BOULDER COUNTY BOARD OF ADJUSTMENT

PUBLIC HEARING

Docket VAR-23-0001: Sombrero Ranch HOA Setback Variance

Request: Variance request to reduce the side setback along the

Figure 2: Zoomed in image of the submitted Site Plan showing proposed improvements. The property boundary is indicated by red line. The proposed fence line is indicated by blue line.

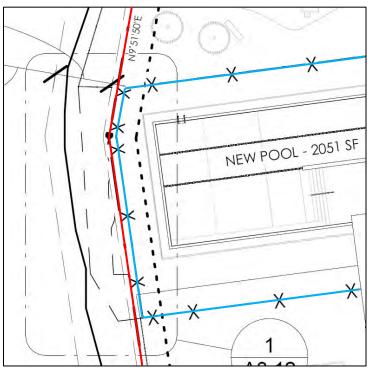
The applicants request a variance from this required side setback to facilitate the construction of a fence surrounding the proposed pool deck. The fence is located within the required 7-foot setback to provide the minimum required distance for safe circulation around the pool. The construction of the proposed fence would encroach approximately 5 feet 5 inches into the required side setback, with the remainder of the fence being located outside of the side setback.

Figure 3: Site Plan showing the property boundaries in blue, the required front setback in red, and the required side setbacks in orange.

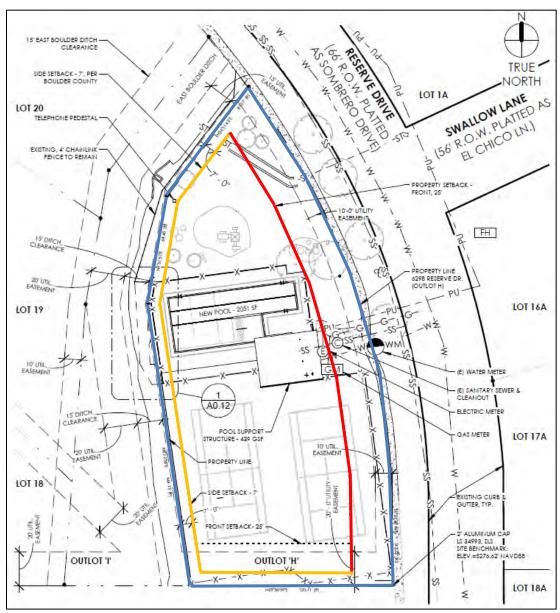
The design of the proposed pool with 25-yard lap lanes causes the fence to encroach within the required side setback for the subject property. Staff finds that the physical circumstances are not exceptional or extraordinary on this property, given that the property is developable with compliance to setback requirements.

Therefore, staff finds this criterion is not met.

Staff finds that the physical circumstances of the property are not exceptional, consequently no exceptional or undue hardship upon the property owner is created. Redesign of the pool is possible to reduce the length of the swimming lanes and comply with required setbacks.
